# UNITED STATES PATENT AND TRADEMARK OFFICE

APPLICATION NO.	FILING DATE	FIRST NAMED INVENTOR	ATTORNEY DOCKET NO.	CONFIRMATION NO.
10/767,599	01/30/2004	Bernardo Ayala	BA01-01U	5201

**Office Action Summary**

## **DETAILED ACTION**

Note the wiring and light bulb support (see Examiner's annotated Figure 3) are considered part of the frame structure where they are attached to the frame structure.

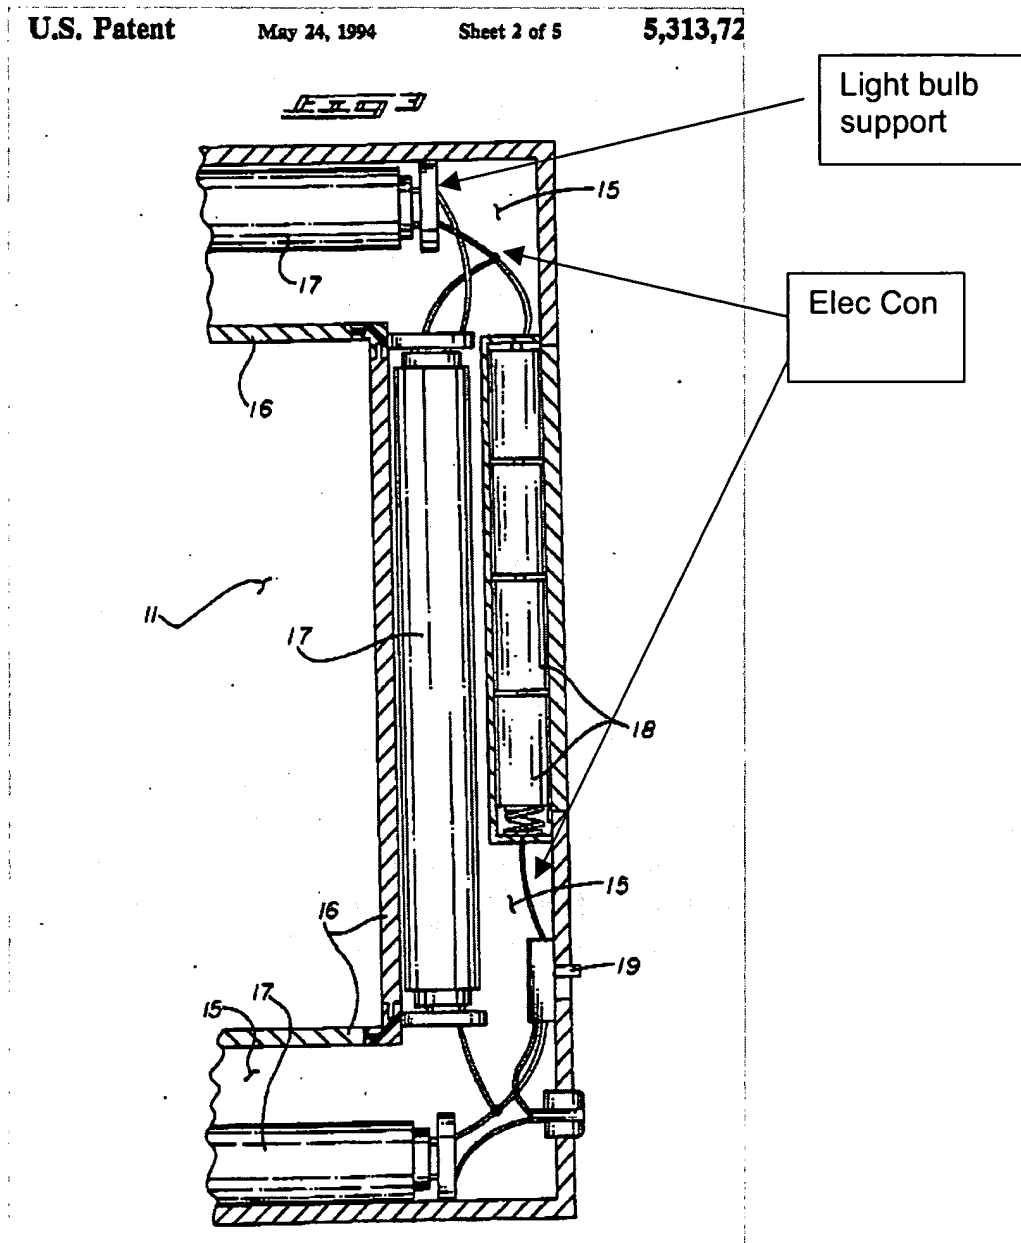
Warner teaches a picture frame with integrated power control and lighting comprising;

a frame structure (12) capable of retaining a replaceable image (11),  
at least one power storage device/battery (18) located within the frame structure (12), as well as an external power source (20) located external to the frame structure,  
a power control device (19) located within the frame structure (12),  
at least one light source (17) located in front of the image located within the frame structure such that light can shine on the front of the image, and  
an electrical connection (Elec Con, see Examiner's annotated Figure 3) located within the frame structure as part of the frame structure that connects the power control mechanism/device (19) and the light source (17).

Note, while no image is shown in Warner, Warner clearly teaches the invention is directed to project illumination onto a central picture mounted about the central support (11), see column 1, lines 41-47, where the picture is for viewing.
